PROJECT INFORMATION

site address	3405/3411/3417 Harbor Ave SW
parcel numbers	7987400130, 7987400140, 7987400150
project number	3034147-EG

10.0 DESIGN REVIEW RESPONSE | itemized response to EDG

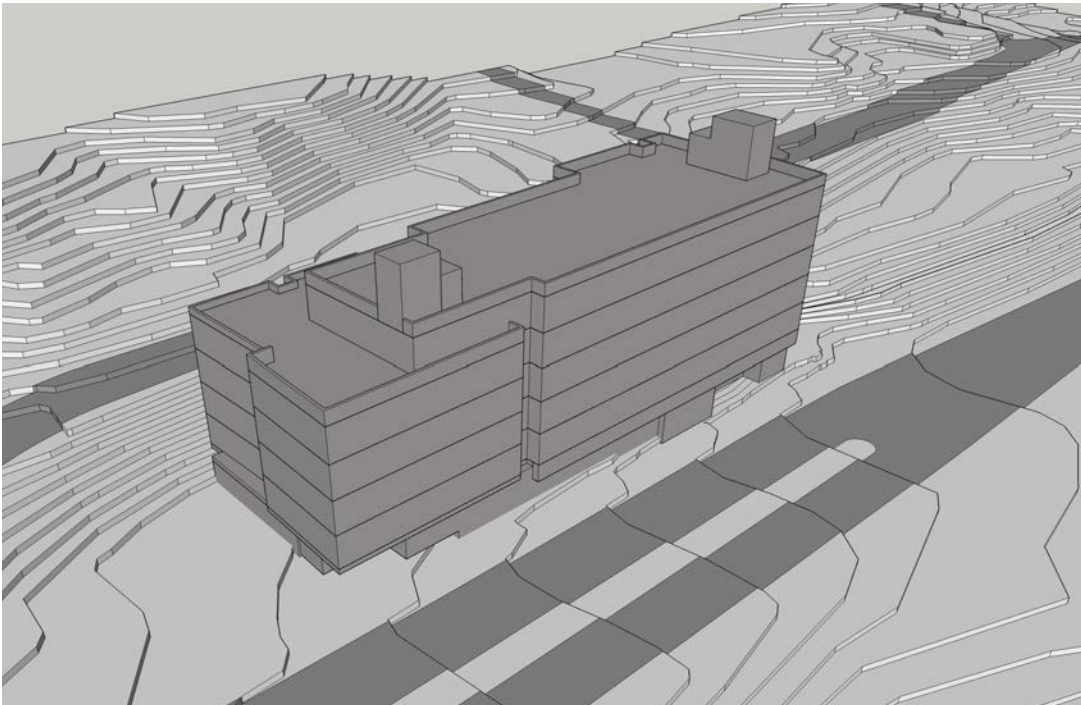
Southeast Corner - The Board was supportive of the beginnings of the southeast corner expression but would like to see the corner be treated as more of a gateway with greater presence through material detailing and perhaps massing refinements. The Board suggested simplifying the massing from a split form to a singular massing volume on the south façade (CS2-A, CS2-D).

Following the Board's guidance, the design team explored a refined and simplified overall massing, particularly at the southwest corner expression. Rather than maintaining a dropped massing at this southwest corner per the EDG proposal, the corner element has been extended vertically by extending to the 5th floor, and continuing the mass down to the grade plane. The modulation of the split form has been simplified, initially with a singular massing volume. Per staff guidance, subsequent development of the massing has reintroduced the gaskets at the south and west facades, but maintains the taller, clarified massing. Larger glazing panels in an expressive pattern, wood tone accents, and a simple siding pattern (related to, but not identical to the rest of the mass) strengthens the south corner and gateway expression.

- The taller, unified massing expression at the south corner signifies its prominence as the main entry and a gateway expression.
- The mass is extended to the grade plane in order to ground the mass.
- A large feature awning has been added to reinforce the corner expression.
- The massing's kink (amplified by the gasket) gestures towards the corner, allowing the materiality of the corner to be expressed differently than the rest of the mass.
- Windows and doors throughout the building are stacked vertically, with the exception of the southeast corner. Here, the staggered windows allow for the incorporation of wood tone panels related to, but distinct from the rest of the building. This distinct compositional order reinforces the corner element.

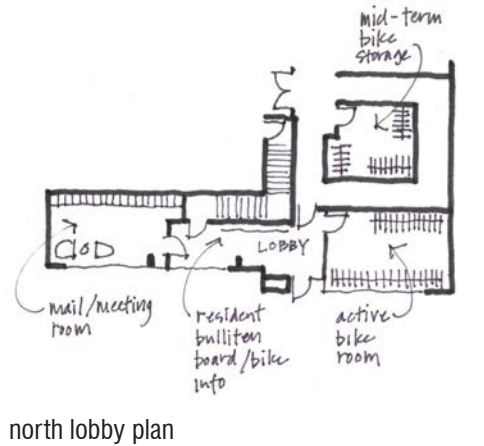
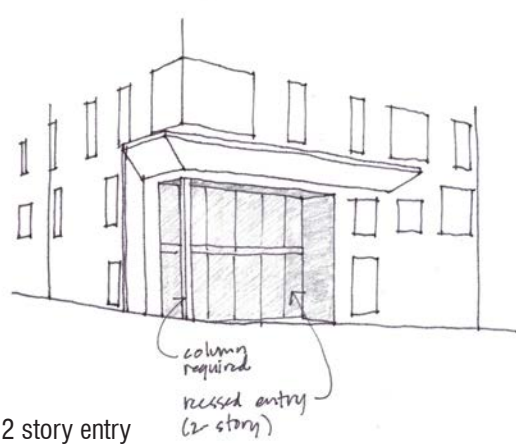
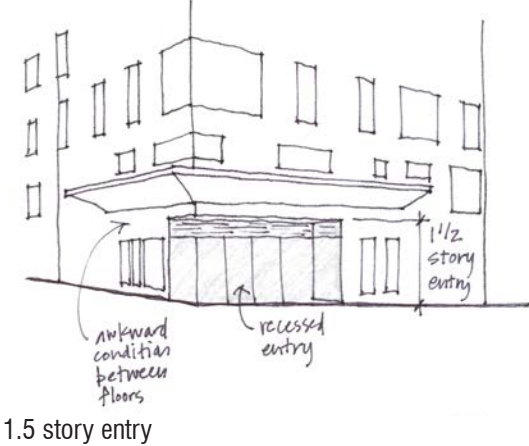
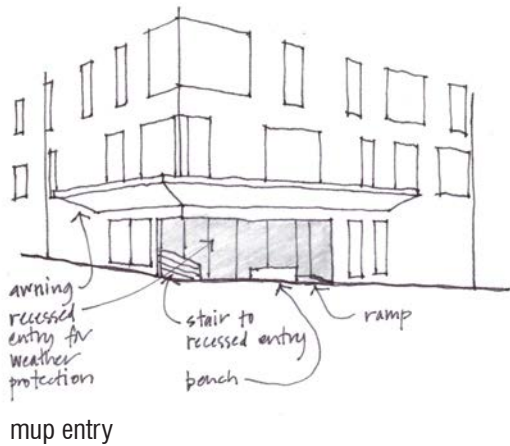
Harbor Ave SW - Related to the corner expression, the Board provided guidance to enhance the expression of the lobby entrance at the southeast corner exploring greater height, size, seating, lighting or other means of enhancing legibility of the entrance. In addition, the Board would like to see the north end exit along Harbor Ave SW become a secondary lobby rather than an egress only (CS2-B2, PL3-A).

Previously, the proposal included a recessed residential entry at the southeast corner, with an exit-only condition at the northeast. The plan has been reworked in order to accommodate a primary entry at the southeast corner and secondary entry at the northeast corner. These entries relate to each other visually, but prominence is given to the southeast entry (as the corner expression) through massing and detailing. The scale, detailing, and proximity to the bus stop of the southeast entry identifies it to visitors as the main public entry, while the northeast entry has been modified and enlarged to function primarily as a resident entry.

The design as proposed at MUP included a sunken entry and a pitched awning at the southeast entry in order to provide additional height. Staff guidance suggested that this created a pinched condition rather than a grandeur entry expression and requested that we evaluate a two-story option. Following that guidance, we evaluated several options including a 1.5 story entry and 2 story entry. However, due to the small unit size above the lobby and the compact lobby itself, this resulted in an awkwardly tall lobby experience while also resulting in the loss of a unit. Focusing on the staff guidance to provide a grandeur entry expression, we have raised the awning, enlarged the lobby to align with the floor above, and treated the fenestration of the unit above in the same manner as the lobby. This design allows for a two-story expression commiserate with the scale of the building

- The taller southern massing, with the larger corner awning, storefront glazing, and wood tone siding immediately identifies itself as the public entrance.
- The awning at the southern massing angles upwards in order to enhance the height and volume of the entry sequence, again signifying it as the main entry.
- The awning at the northern entry reflects the same material palette, in a more modest scale, prioritizing function.
- Exterior signage and lighting have been provided at both entries, with a priority in size given to the southeast entry.

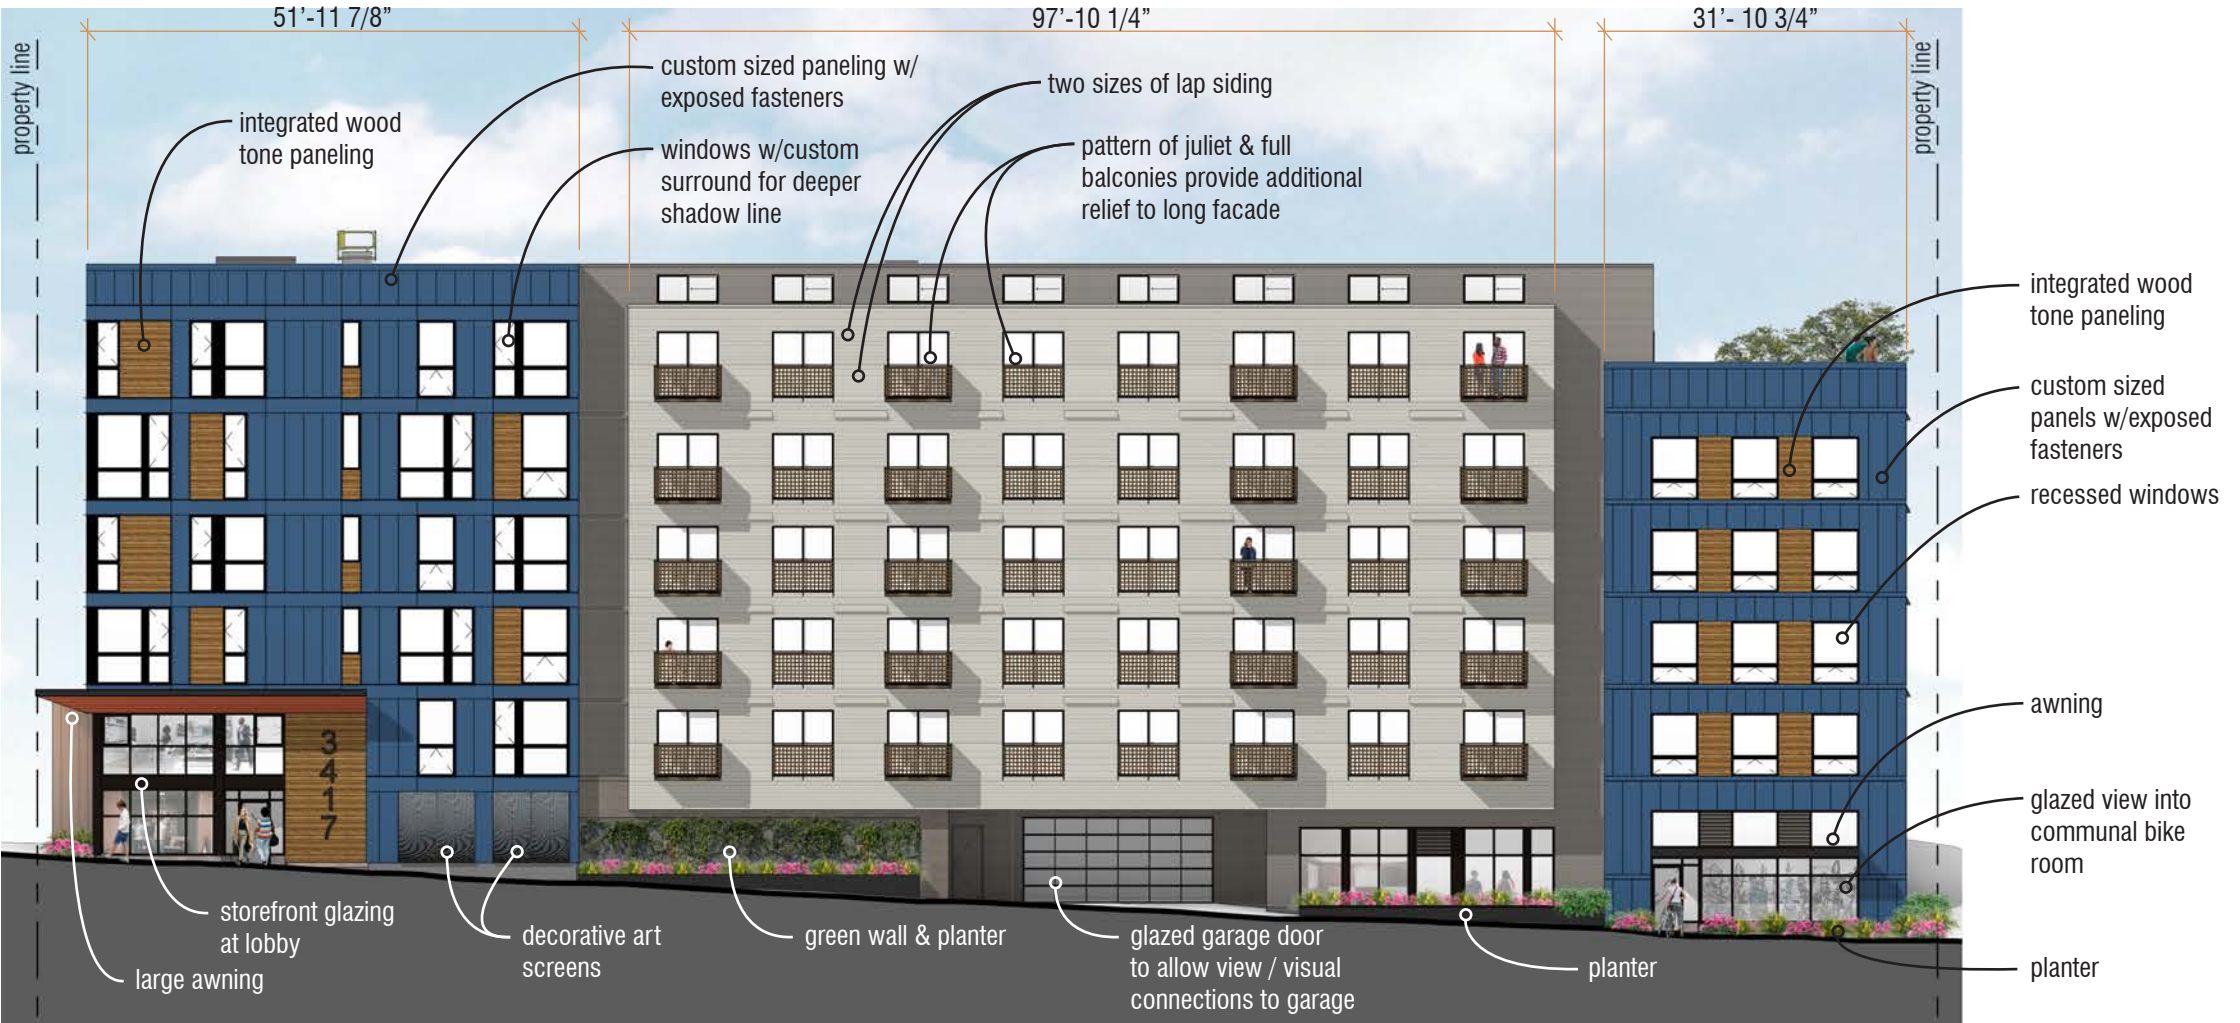
Harbor Ave SW - The Board was concerned with the 126' façade length along Harbor Ave SW . At the next meeting the Board expects to see material application and secondary detailing to break up and provide a smaller scale to this long street frontage (CS2-D, DC2-A, DC2-B1)

In response to the Board's guidance regarding the massing of the southeast corner expression, stepping down the massing at the north edge, and providing a secondary northeast entry, the massing has now been broken into three, with the northern and southern nodes connected by a central interlocking bar. Additionally, gaskets have been provided, separating each mass, which aids in further breaking up the overall length of the façade. The addition of balconies and julets as secondary elements at the center mass help to further break down the length of the façade. At the ground level, programmatic elements have been rearranged to accommodate additional glazing and visual interest.

- The proposal seeks to use different siding and fenestration languages to create visual interest and movement along the street frontage; the north node uses a lively siding pattern with regimented windows, while the southeast corner expression uses a regimented siding pattern with lively fenestration and wood tone paneling. The central interlocking bar utilizes a connective horizontal banding pattern for the floors above, and horizontal board formed concrete for the garage level.

- On the upper floors, siding type and detailing such as recessed windows and doors on the north and south nodes bookend the structure. Secondary detailing is provided with balconies and julets.

- The north and south nodes' glazed entries and landscaping adding visual interest at the ground level.
- The quantity of car parking fronting the street façade has been reduced, with a communal mail / meeting room and bike parking provided at the ground level. This allows for increased fenestration and visual activity.

- The section of wall without fenestration has been significantly reduced from the EDG proposal. Greenscreens and planters are provided along this section, which will help break up the façade length while contextually responding to similar planters in the neighborhood.

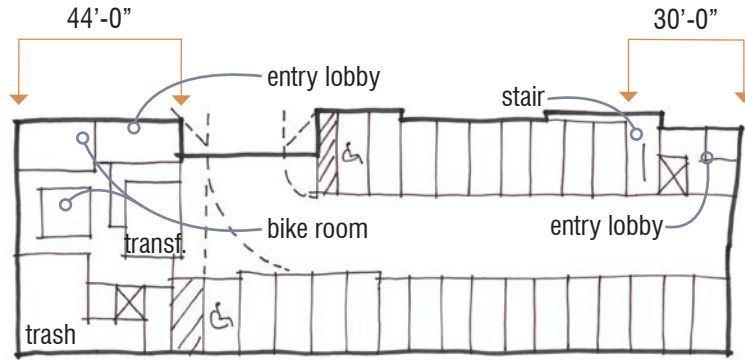
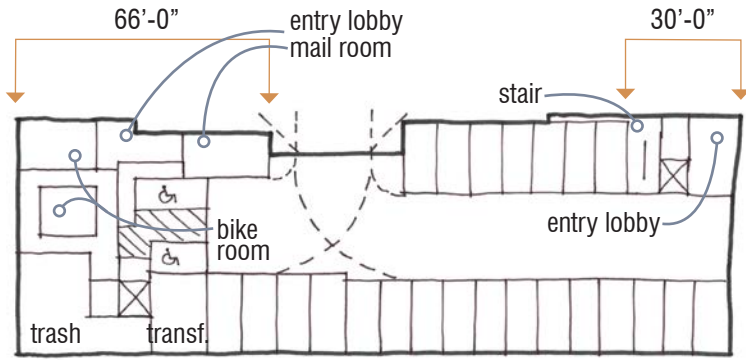
Harbor Ave SW - The Board was concerned with blank wall along the parking garage level and provided guidance to further explore alternative layouts of the floor plan with the goal of improving visual interest and activation along the street-level. The Board suggested swapping out the bicycle storage and parking spaces (DC2-B2, DC1-C2).

Per the Board’s guidance, we evaluated several new parking layouts that would accommodate reduced parking fronting the street façade. In particular, it was suggested that we flip some of the car parking and bike parking, so that there could be a more active front façade. We evaluated several different options for the parking layout, and ultimately revised the plan in response to the Board’s guidance.

- By rearranging the parking, we were able to reduce the parking at the front façade from 98’ to 61’ (for a reduction of approximately 40%)
- We eliminated the interior storage and exit-only corridor on the north end of the building in favor of a new secondary lobby, mailroom, and bike storage all with fenestration to help activate the façade.

- The blank wall directly in front of the parking is mitigated with the addition of planters and green screens.
- The section of wall without fenestration has been significantly reduced from the EDG proposal. Greenscreens, planters, and an art screen incorporating signage are provided along this section, which will help break up the façade length while contextually responding to similar planters in the neighborhood.

- In an effort to provide even more transparency, the garage door (which will remain mainly closed) will be glazed for transparency. Additional safety features at the garage entry/exit include full sight triangles (no request for reduction) and patterned/grooved pavement at the garage entrance to alert pedestrians of this access point.

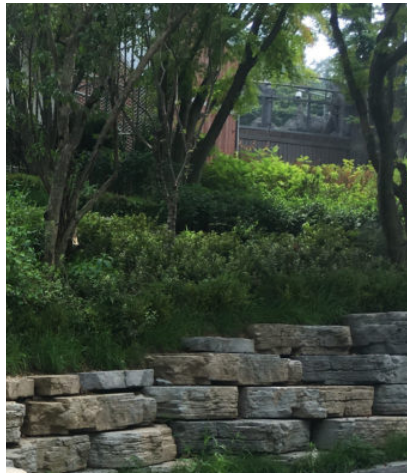
30th Ave SW - Along 30th Ave SW the Board would like to see further refinement that creates a more neighborly response, perhaps creating a connection to the courtyard or common residential entry, terracing slope down to the courtyard and patios, and clarifying both the landscaping and fall protection along this edge (DC2-A1, CS1-C).

The steep slope located between our property line and the edge of the road provides a variety of challenges. As part of the SIP review process, the design team has been coordinating directly with SDOT on the required street improvements. As such, these improvements have an impact on the relationship between the street on 30th Ave SW, the steep slope, and the project’s intended courtyard.

- In coordination with SDOT, the sidewalk will be provided on the west side of the street, in order to connect safely to the greater sidewalk network. The street will also be widened in an effort to better support the existing neighborhood, as well as provide safe transit for fire and medical vehicles. The west side of the street will have a curb, and where required a retaining wall (less than 4’ tall) with safety guard as required along the edge of the slope.

- A residential entry has been added to the northwest node as recommended by the board. A stair and associated bike runnel have been provided in order to allow residents a neighborly, and easy access to 30th and beyond.

- Several of the 1st floor units have access to patios, and the majority of the upper level units have balconies which help to activate the façade and provide a direct visual connection to 30th Ave SW.

- Bio-retention planters aid in terracing the slope, allowing for a more gradual transition between the property line and planter edge.

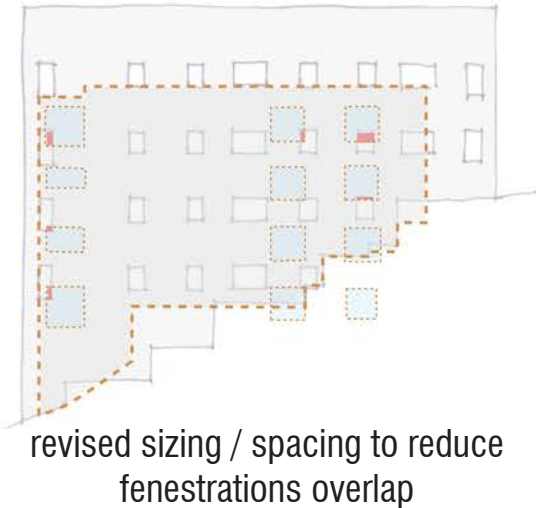
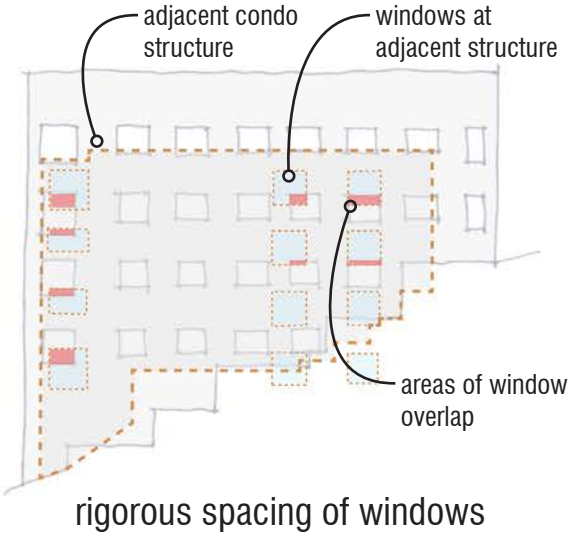
North Edge - Echoing public comment, the Board was unclear on the relationship of the proposed massing to the adjacent building to the north. At the next meeting, clarify this condition with sections and window privacy studies. In addition, the Board noted it may be more beneficial to provide a step down in massing at this edge than at the south end and would expect to see exploration of this at the next meeting (CS2-D5).

Per the Board's guidance, the taller more prominent corner of the building has been relocated to the south edge, allowing the building to step down adjacent to the neighboring structure. Care has been taken to reduce the impact of the new structure on the neighboring building. A variety of roof deck locations were explored, however programmatically we believe it is important to locate the roof deck connected to an indoor amenity space in order to be more usable throughout the year and various weather conditions. With the dropped massing along the north per the Board's guidance, the roof deck is located to the north as well.

- Previously, the massing was located 5' from the property line on the north side, and was a full 5 stories over a basement tall. In response to the Board's guidance and neighborhood comments, the building has been shifted and now tapers from 4'-4" (adjacent to the section of blank wall) to 7'-5" (adjacent to neighboring windows) from the shared property line. Landscaping has been provided between the building and property line edge to further mitigate the impact of the building.

- The massing has been modified to step down at the northern edge, in response to the neighboring building.
- Glazing on the north façade has been minimized and studied to avoid conflict with the neighboring windows as much as possible, and per neighborhood comment no private balconies are proposed along this facade.

- A landscape buffer including trees is provided on the roof deck to screen the neighboring property from the public amenity space, keeping residents away from the edge and further from the neighboring structure.
